**Re: 5165Q – Supply and Delivery of Pool Air Handling Unit and Heat Recovery Ventilator - Addendum # 2**

**Equipment Schedule 15961 – Heat Recovery Ventilator**

Watermania  
TAG: AHU-13

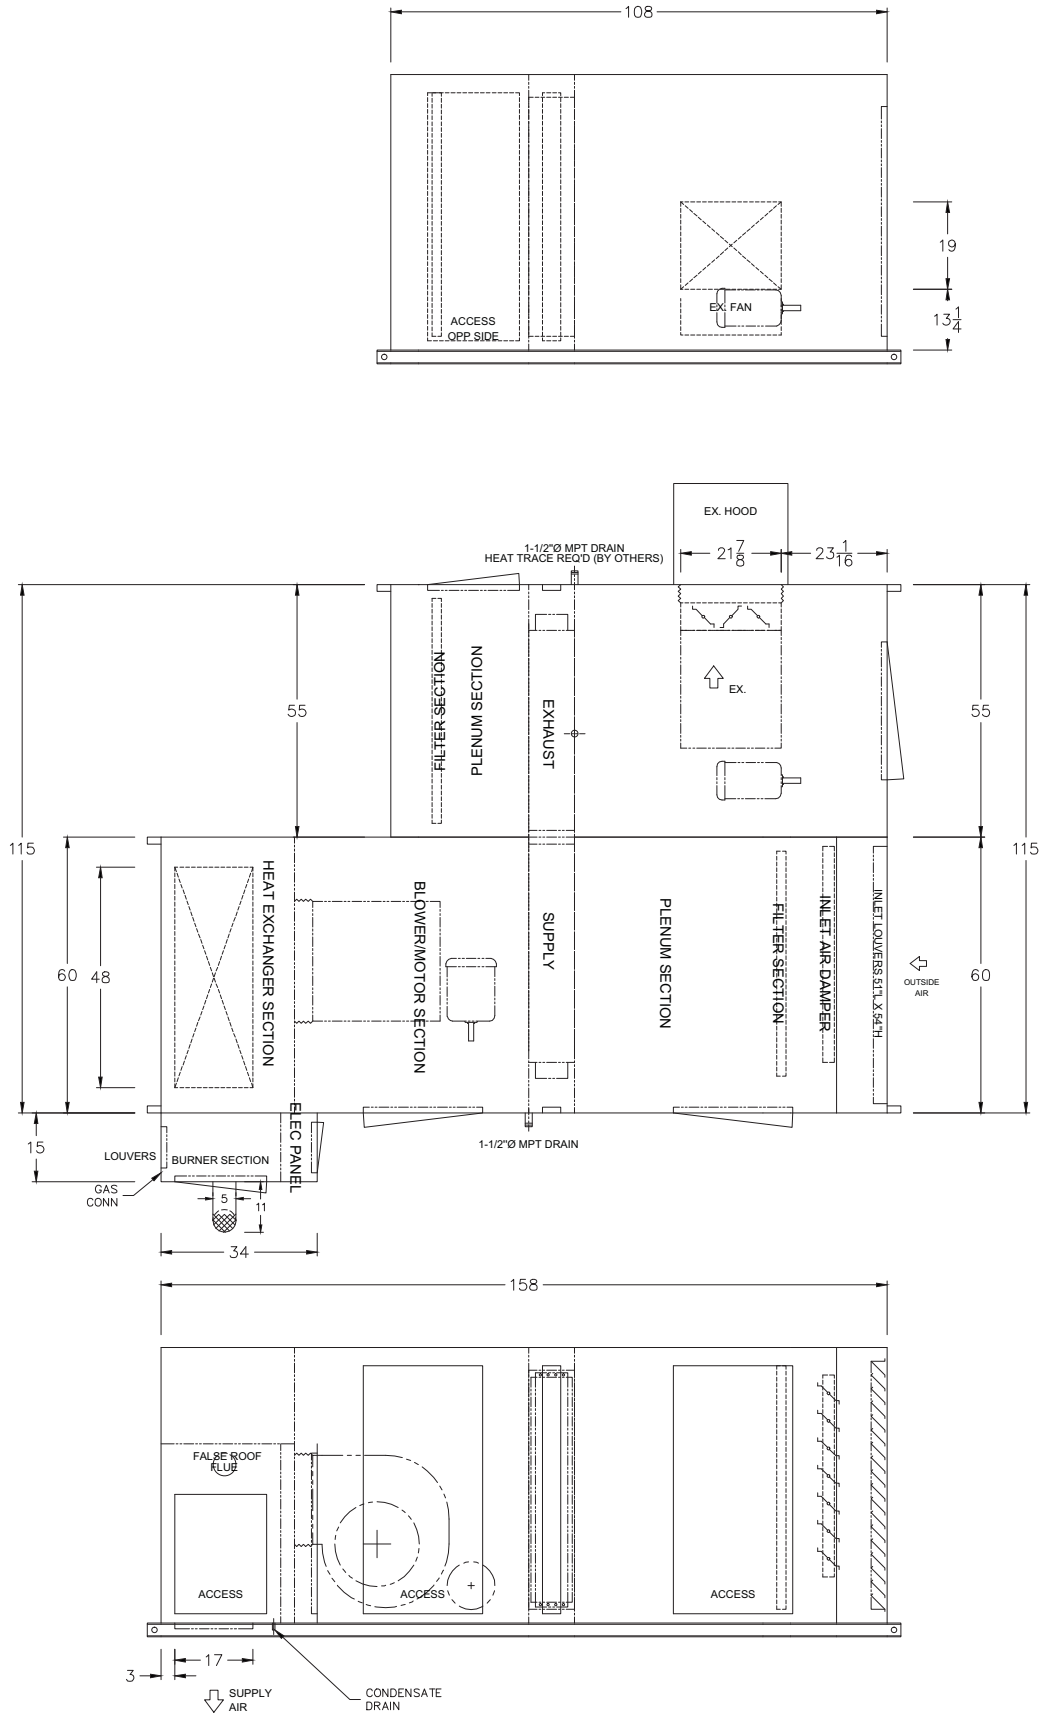
1. Revise: AHU-13 performance specifications
  - 1.1. Model: Engineered Air DJS40/0/HRP or equivalent
  - 1.2. Fan Type: Forward Curve
  - 1.3. Supply Fan motor H.P to be revised to: 7.5
  - 1.4. Heating Input to be revised to: 400 MBH
  - 1.5. Heating Output to be revised to: 320 MBH
  - 1.6. Leaving air temperature to be revised to: 60F

2. **Add: AHU-13 drawing attached for reference.**
  - 2.1. Specification Section 15763 – Air Handling Units
  - 2.2. Add: Clause 1.1.1.4 – Custom roof top air handling unit to be complete with O/A intake hood
  - 2.3. Add: Clause 1.1.6 – Air handling unit to be supplied complete with damper actuators. All controls to be wired to a terminal strip for connection by others.
  - 2.4. Revise: Clause 2.6.1 and 2.6.2 – Liner to be revised to a solid aluminum liner
  - 2.5. Revise: Clause 2.7.3 – All access doors shall be lockable
  - 2.6. Revise: Clause 2.7.10 – A silencer is not required for the unit.
  - 2.7. Revise: Clause 2.11 – Unit shall be complete with only 1 filter section with minimum Merv 8.
  - 2.8. Add: Clause 2.12.8 – Dampers shall be Tamco 1500 SW or equivalent.
